Reference: Engineering Services 233 Eiser Rd. Lillington, NC Project No.: 09GAR-F540

## HARNETT COUNTY

PERMIT # 09-50023306

ADDRESS: 233 eisler

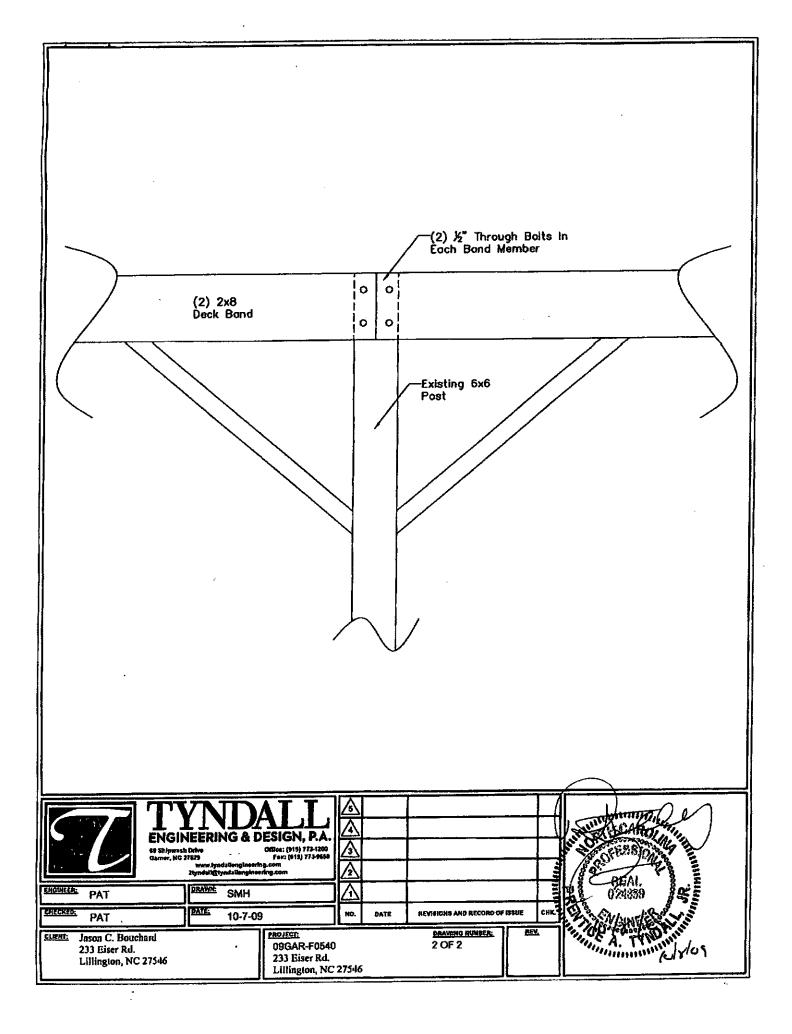
- Based on our observations and analysis, the existing framing is adequate as constructed to support the anticipated loading conditions. However, the existing (2)2x8 header should be secured to the existing 6x6 posts with (2) 1/2" through bolts per connection. The reader is referred to the attached diagram for details. Additionally, a Simpson H2.5 clip should be added to each rafter at the (2) 2x8 header connection.

- 3) Based on our observations and analysis, the existing framing is adequate as constructed to support the anticipated loading conditions. However the existing (2)2x8 band should be secured to the existing 6x6 posts with (2) 1/2" through bolts per connection. The reader is referred to the attached diagram for details.
